THE CITY OF SAN DIEGO  
Development Services Department  
1222 1st Avenue, San Diego, CA 92101

**Project Address** 2349 Rue Adriane  
San Diego, CA 92037

**Project Type** Discretionary Project

<p>The following issues require corrections to the documents submitted.</p>

[ [Comment 00032](#) | [Sheet A100](#) | [Open](#) ]

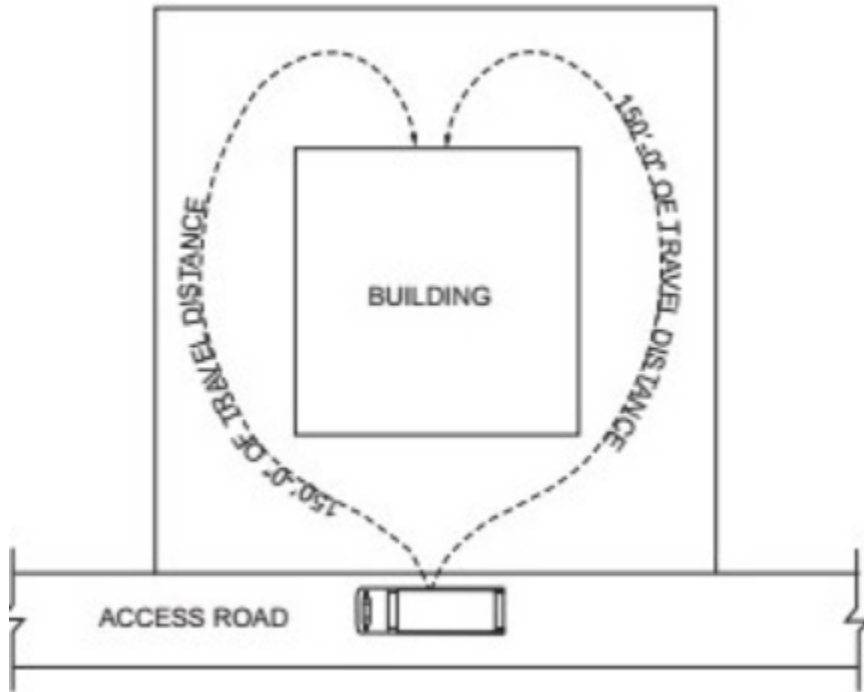
The hose pull measurement shall begin 10 feet from the curb to account for parked cars and other potential obstructions. However, if the curb is designated as a fire lane, the measurement shall start from the edge of the curb on the project side of the road.

CODE - CFC 503.1.1 Buildings and facilities. Approved fire apparatus access roads shall be provided for every facility, building or portion of a building hereafter constructed or moved into or within the jurisdiction. The fire apparatus access road shall comply with the requirements of this section and shall extend to within 150 feet (45 720 mm) of all portions of the facility and all portions of the exterior walls of the first story of the building as measured by an approved route around the exterior of the building or facility.

COMMENT - All portions of the exterior perimeter of new buildings shall be within 150' (non-sprinklered) or 200' (sprinklered) of a fire access road. Show hose pull on plans.

Refer to San Diego FPB Policy A-14-1, Fire Access Roadways, CFC Section 503. And Appendix D of the 2019 CFC.

COMMENT #	RESPONSE	REFERENCE
32	Hose pull shown on site plan	A100
41	No response required	
42	Aerial access shown on site plan	A100
43	Brush management shown	A100, L1-L3
44	Block wall at 10' and 4' paths shown on site plan	A100

[ Comment 00042 | Sheet A100 | Open ]

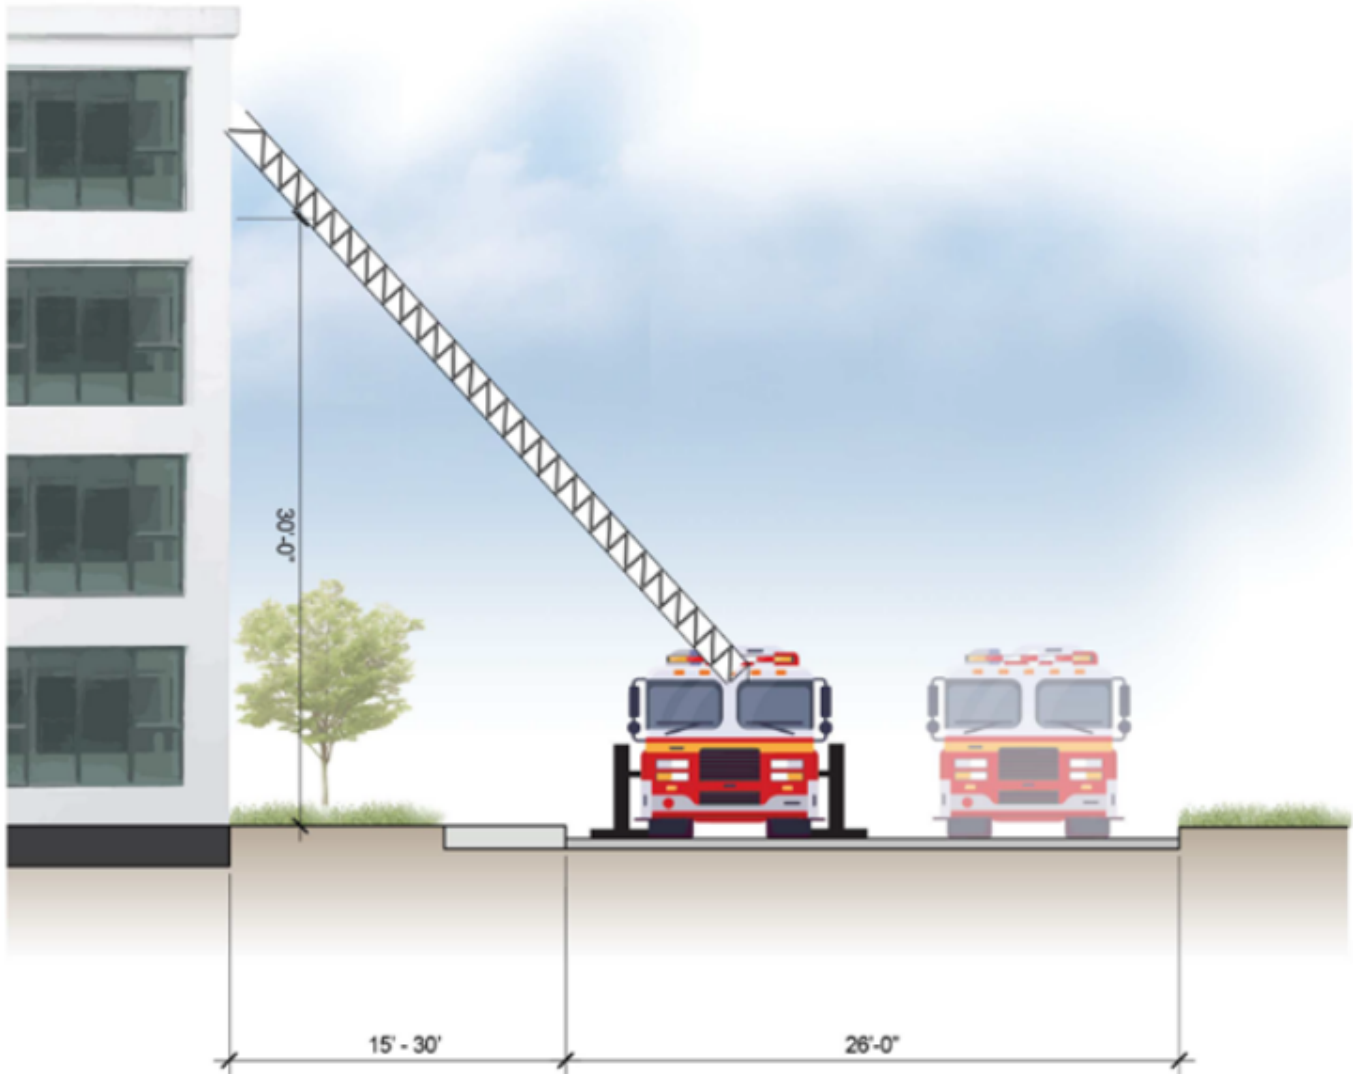
**Aerial fire access:**

Aerial fire access road(s) adjacent to buildings that are greater than 30 feet in height from the grade plane shall have a minimum width of 26 feet. The proximal edge of Aerial fire access shall be a minimum of 15-30 feet from the building facade(s) and/or plumb line of eave(s). Aerial access shall be provided along one entire long side(s) of the building(s). Show ALL proposed locations where aerial access is being provided. (See FPB Policy A-14-1)
